RETROSPECTIVE PLANNING APPLICATION FOR THE ACCESS TO EXISTING GARAGE AND WORKSHOPS AT SMITHS AT PINWALL (APPLICATION REFERENCE: 25/00444/FUL)

Title: Proposed Changes to Constructed Layout

Road Safety Audit Stage 1

STAGE 1 ROAD SAFETY AUDIT RESPONSE REPORT

Swept Path Analysis of Box Van

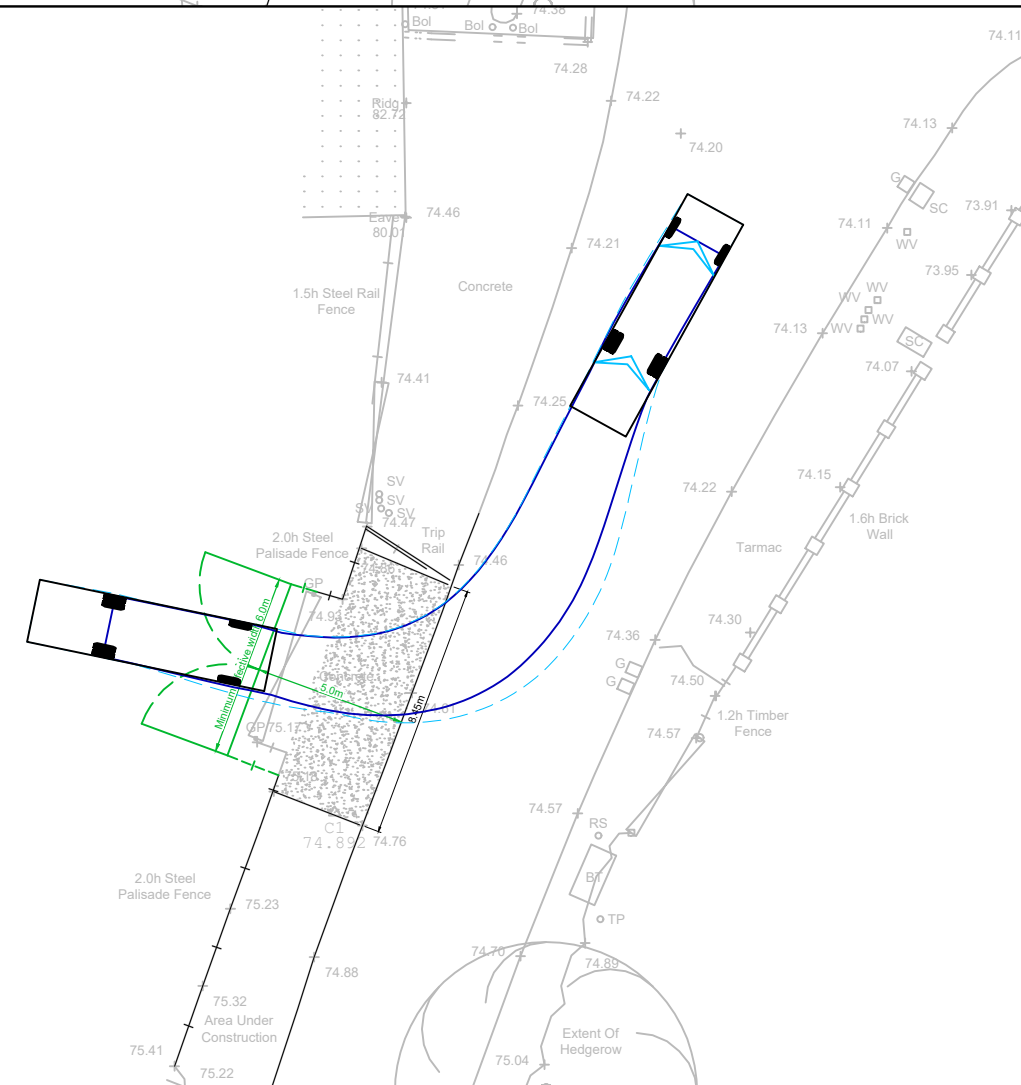
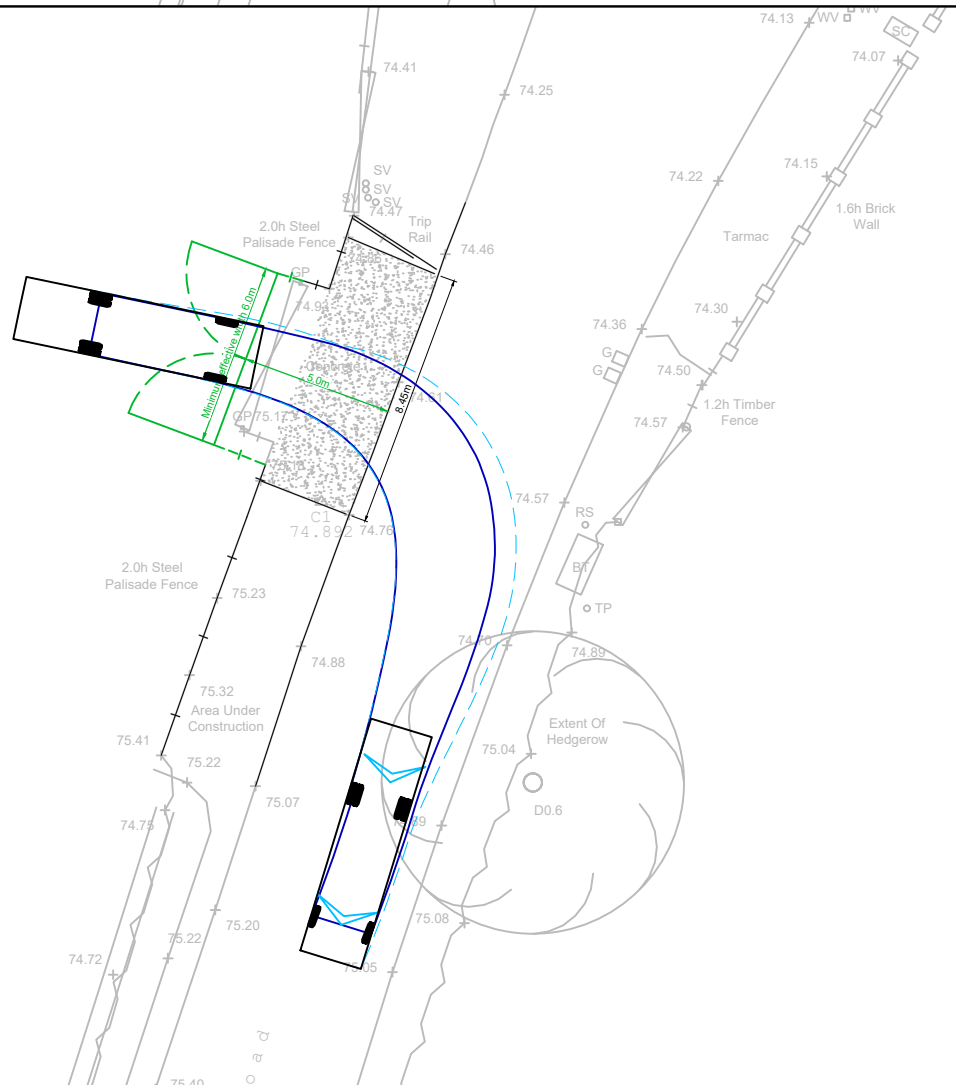
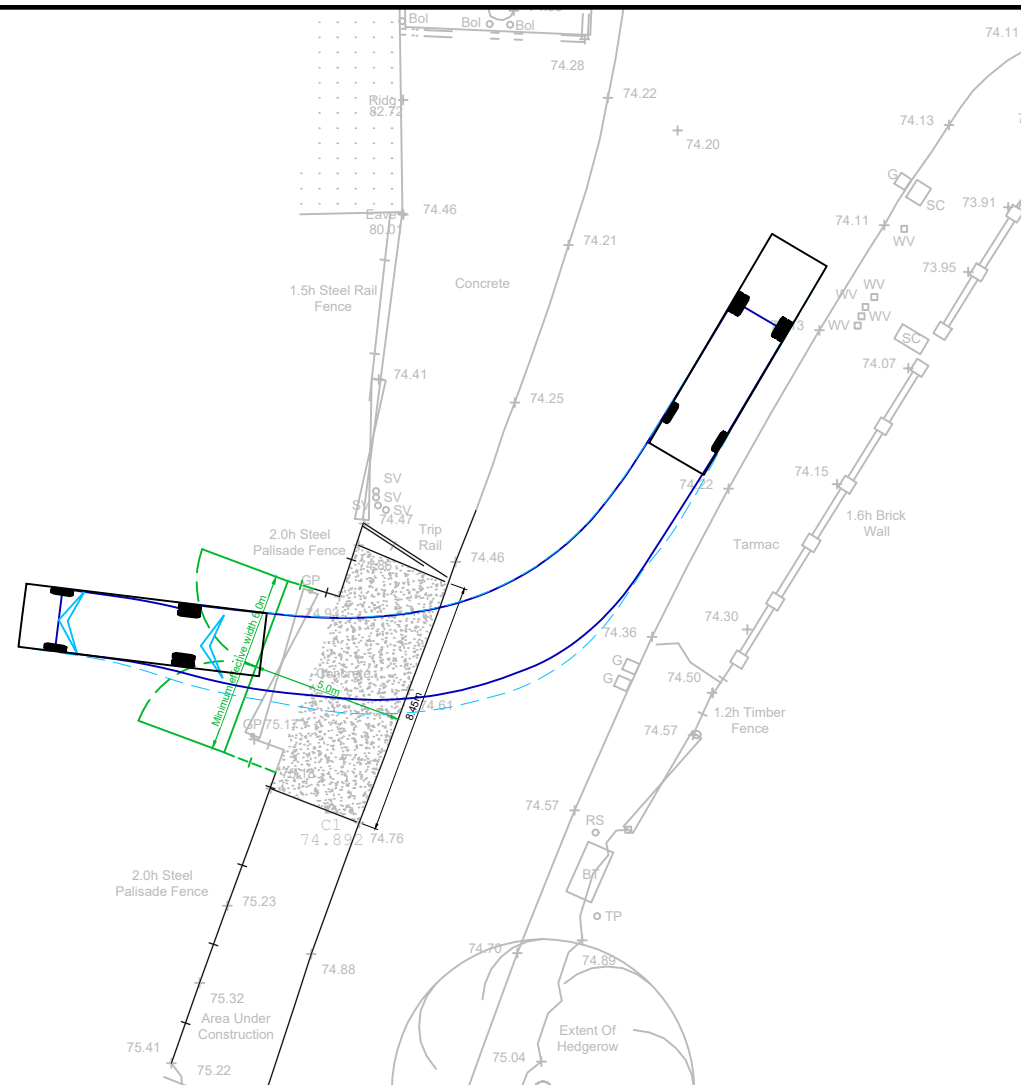
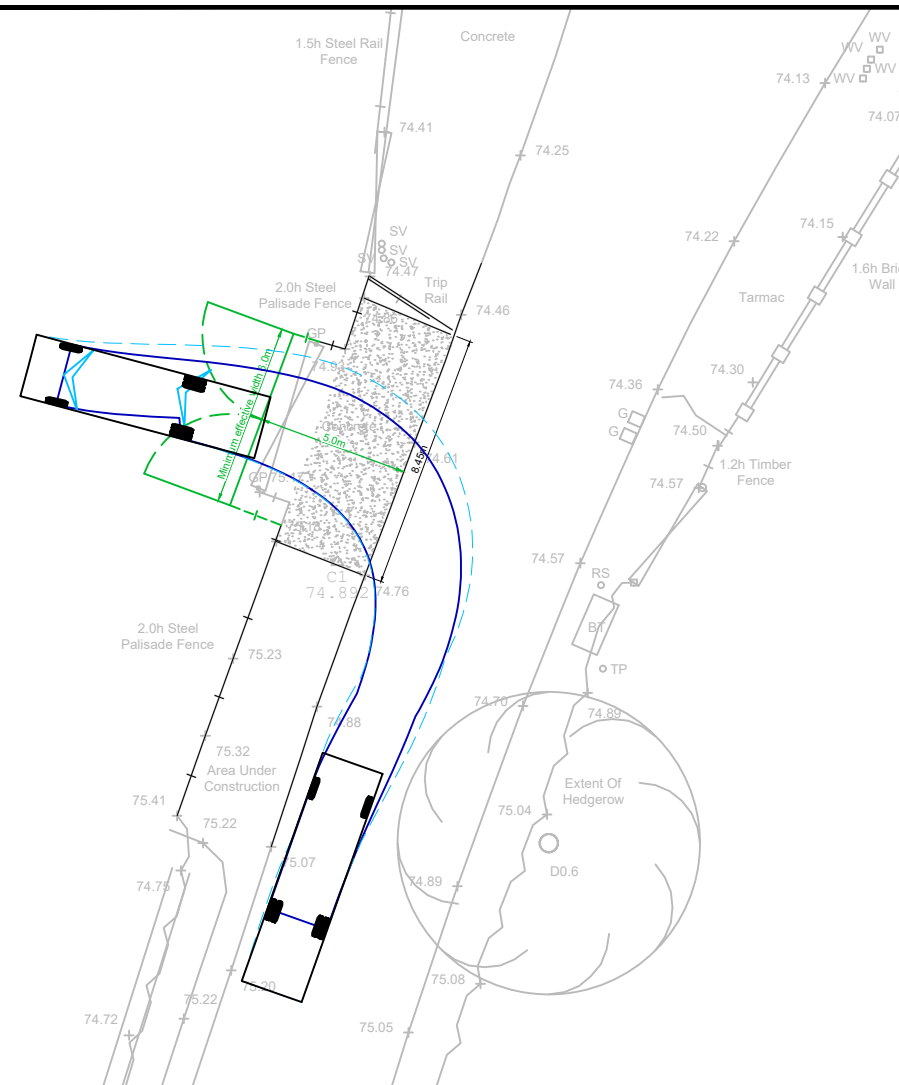
As outlined above, LCC have requested confirmation that the swept path analysis previously provided by Dynamic Transport Planning was undertaken at a speed of 15kph. Given the updated access arrangement in compliance with Table 15 of LCC's Highway Design Guide, an updated swept path analysis of a box van has been produced as shown in the enclosed **Drawing 3801-ADC-HGN-XX-DR-CH-**

The Applicant should confirm that the swept-path analysis previously provided for a 7.5t box van was undertaken at a speed of 15kph.

0100-S1-P01. The drawing confirms a box van would be able to enter and exit the site in both directions based on a speed of 15kph.
